### APPEAL SUMMARY

**Status:** Hold for Additional Information - Reconsideration of ID 31417, item 1

<b>Appeal ID:</b> 31464	<b>Project Address:</b> 406 NW Glisan St
<b>Hearing Date:</b> 4/12/23	<b>Appellant Name:</b> Jordan Bissett
<b>Case No.:</b> B-004	<b>Appellant Phone:</b> 5032339856
<b>Appeal Type:</b> Building	<b>Plans Examiner/Inspector:</b> Renay Radtke Butts
<b>Project Type:</b> commercial	<b>Stories:</b> 3 <b>Occupancy:</b> A, B, R-1 <b>Construction Type:</b> V-B
<b>Building/Business Name:</b> Enterprise Building	<b>Fire Sprinklers:</b> Yes - throughout
<b>Appeal Involves:</b> Alteration of an existing structure	<b>LUR or Permit Application No.:</b> Appeal 31417
<b>Plan Submitted Option:</b> pdf [File 1]	<b>Proposed use:</b> Assembly & Business

#### Appeal item 1

LEVEL 01 FLOOR  
PLAN

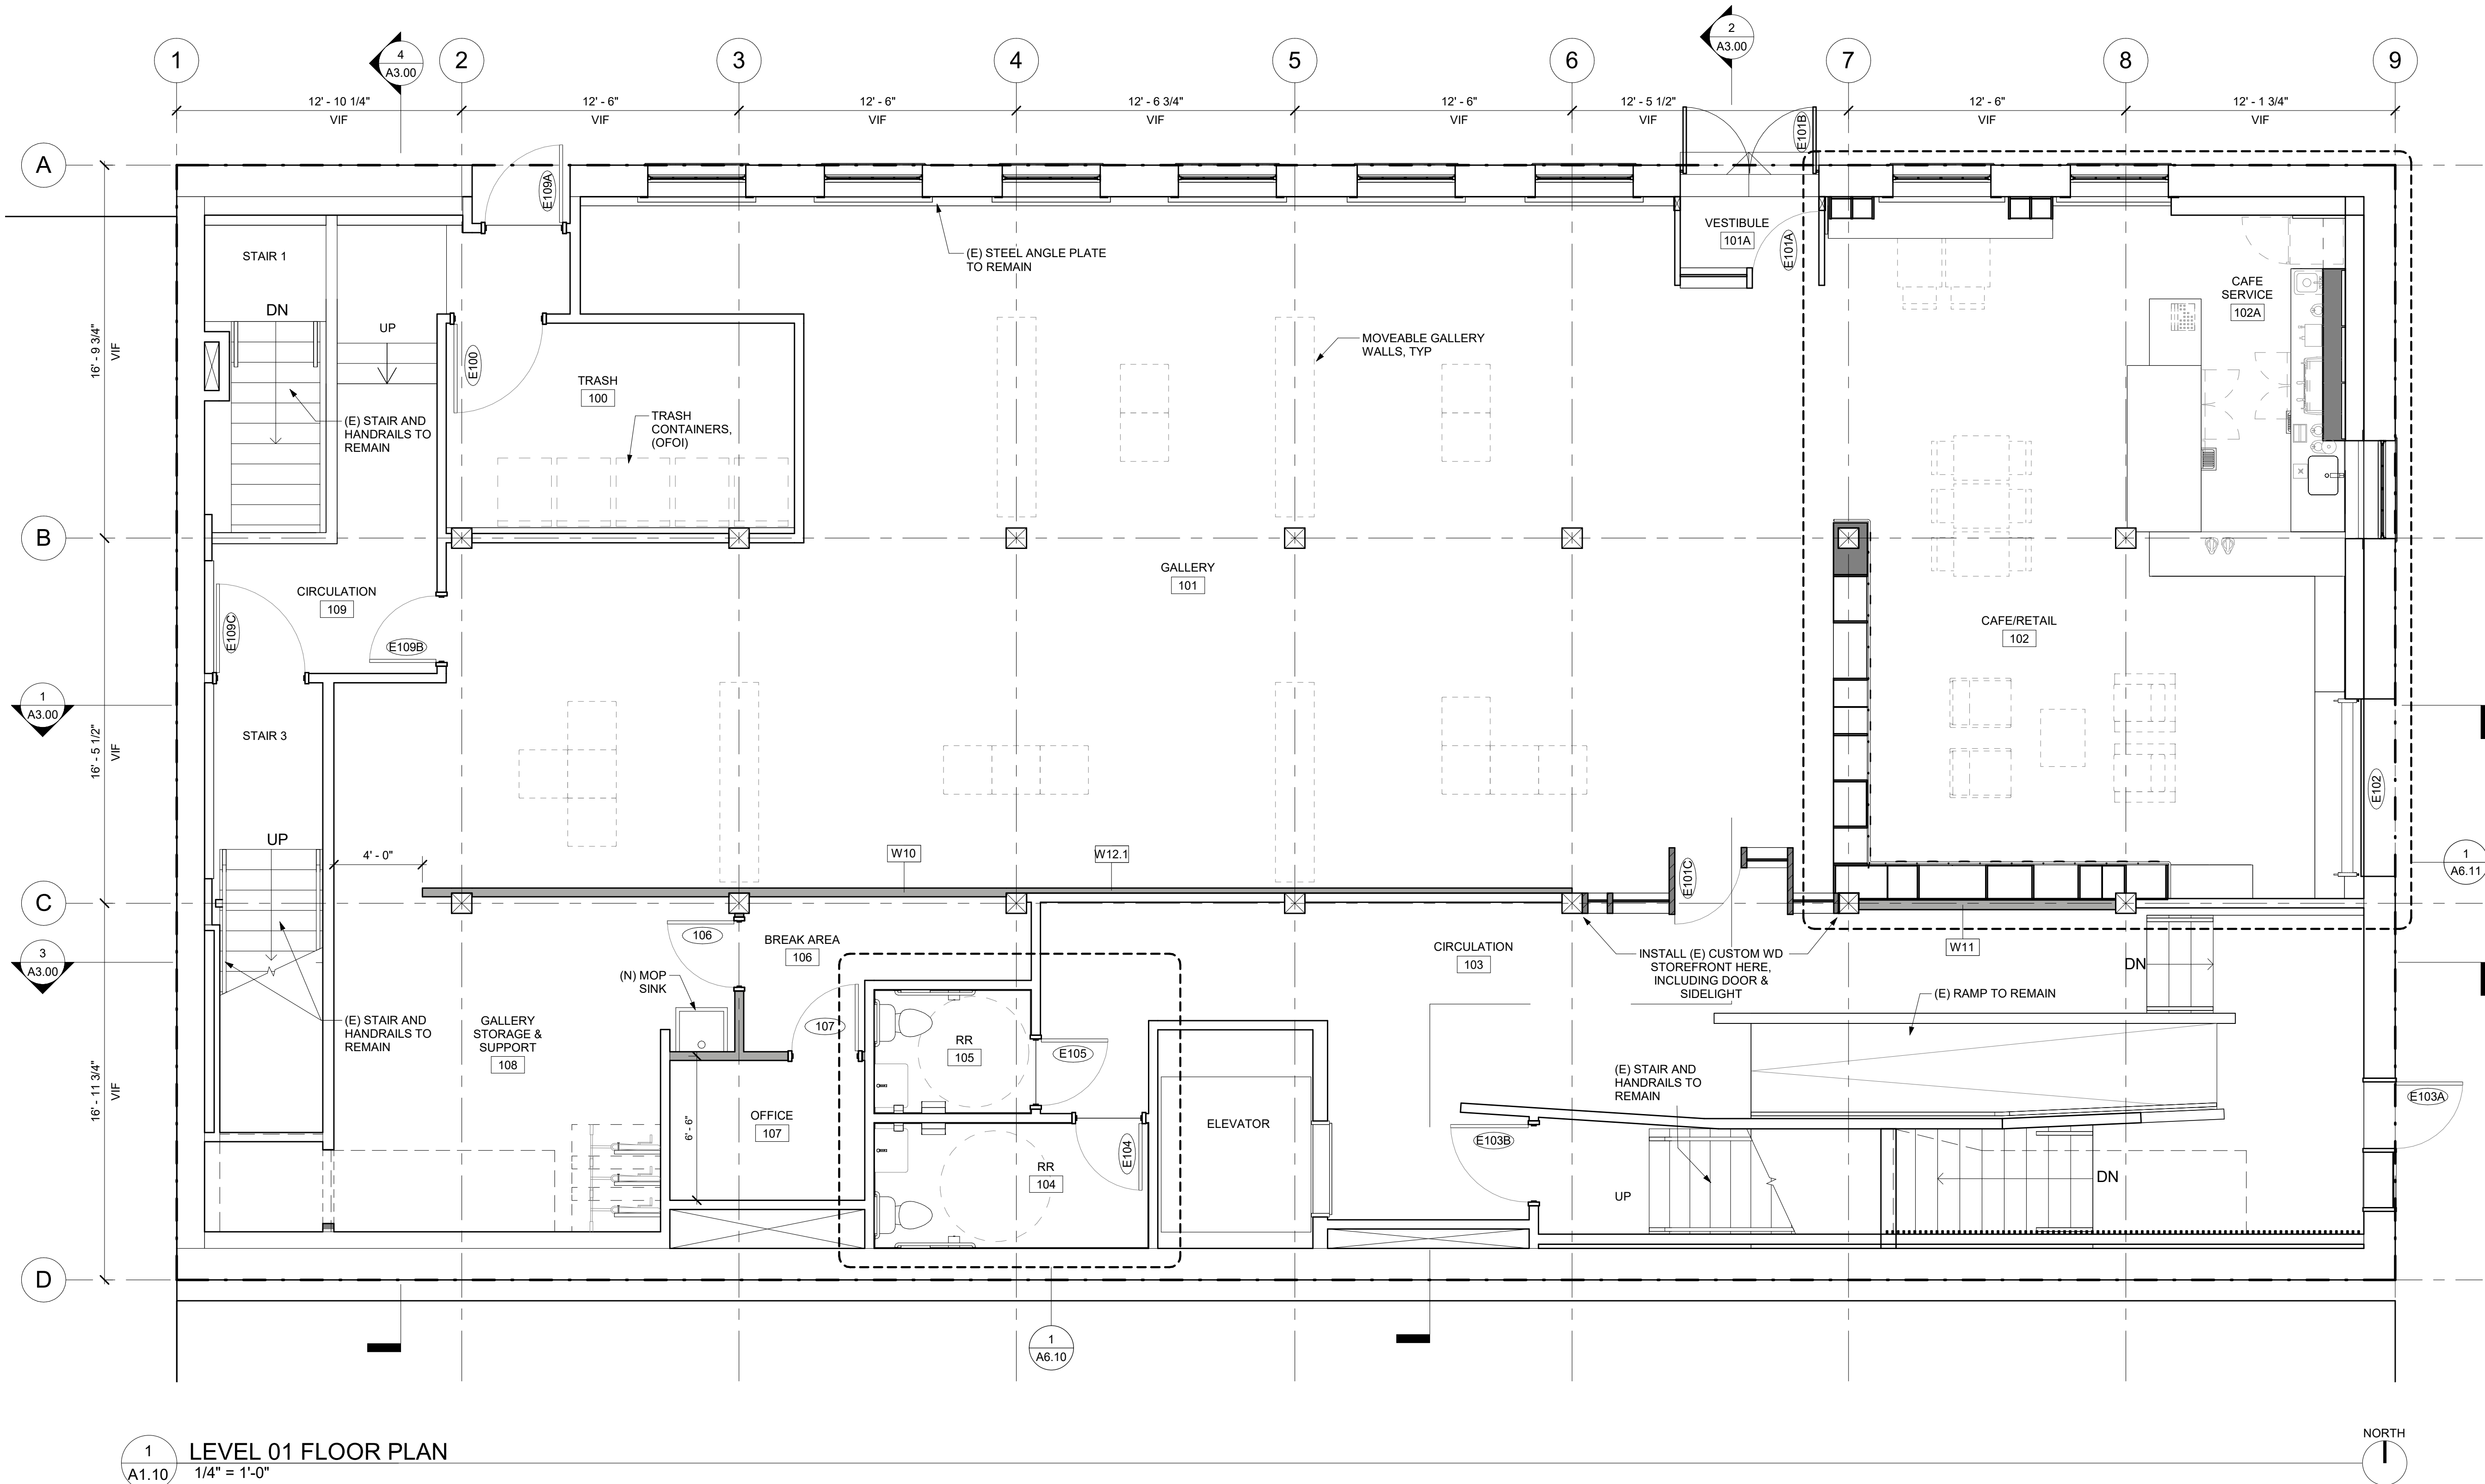
**Code Section** 1024.1

**Requires** 1024.1 Exit passageways.  
Exit passageways serving as an exit component in a means of egress system shall comply with the requirements of this section. An exit passageway shall not be used for any purpose other than as a means of egress and a circulation path.

**Code Modification or Alternate Requested** Use the existing Trash room configuration.

**Proposed Design** The existing Trash room is at grade with the sidewalk and exit door. It is accessed by an in-swinging door opposite the exit door. The remainder of Level 01 is approximately 1'-8" above grade. The stairway from the upper levels and the exit passageway including the stairway from the Basement is enclosed in an existing 1-hr fire barrier. The Trash room is enclosed separately in a 1-hr fire barrier.

Trash room is separated from Exit Passageway by existing 3-hr door.

**Reason for alternative** Leaving the Trash room and its access in the existing configuration as permitted in 2004 provides the lowest overall risk to building users for the following reasons:

Given the need for proximity to the exterior for unloading, the Basement bar/restaurant and the Level 01 Café, there is no other feasible location for the Trash room within the building. The building is a Historic Landmark and modifying or adding additional openings in the exterior is not likely to be allowed by the Historic Design Commission or SHPO.

The only feasible way to reconfigure the Trash room in the existing location would be to raise the floor to be the same height as the remainder of Level 01 and provide access on the south side of

the room via the Gallery.

However, this creates additional barriers for building users to the Trash room, including placing access door further from the exit, and requiring access through an additional door, which is likely to be propped open.

Finally, the single largest trash generator in the building will be the Basement bar/restaurant. Accessing this alternate configuration would require users to go against the direction of egress in the Level 01 exit passageway, and travel further from the exit door to bring trash from the restaurant to the Trash room. This increases the likelihood they will simply deposit trash in the exit passageway until it is taken out, thus increasing the fire hazard and impediment of this critical means of egress.

**Separation of Trash Room from Exit Passageway: Hold for additional information.**
